SERVICE *No.* 974 BULLETIN

DATE: October 19, 1994

Aileron Hinge Inspection and Replacement

PA-31, 31-300, 31-325 Navajo
PA-31-350 Navajo Chieftain
PA-31-350 T1020
PA-31P-350 Mojave
PA-31T3 T1040

SKETCH A

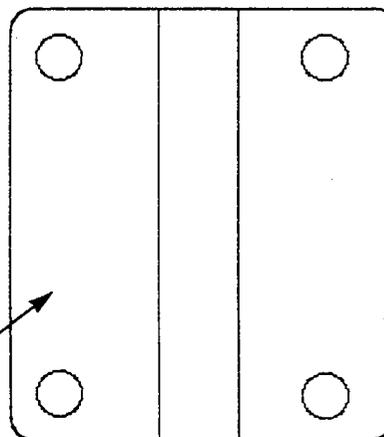
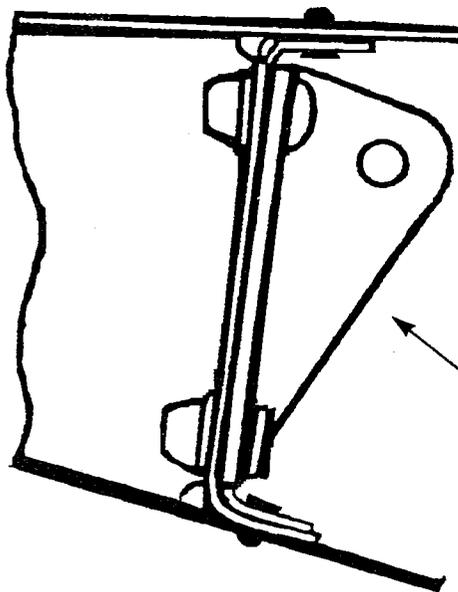
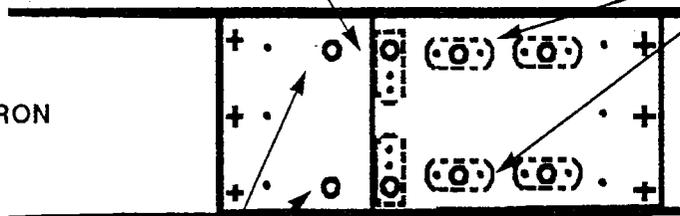
INSPECT:
CRACKS WILL
APPEAR ALONG
SPAR FLANGE
AND AT ATTACH
HOLES.

ADD HOLES & NUTPLATES

EXISTING HINGE HOLES

INSPECT:
CRACKS WILL
APPEAR ALONG
SPAR FLANGE
AND AT ATTACH
HOLES.

INSTALL NEW HINGE
P/N'S 74461-02 (LEFT)
AND 74461-03 (RIGHT)
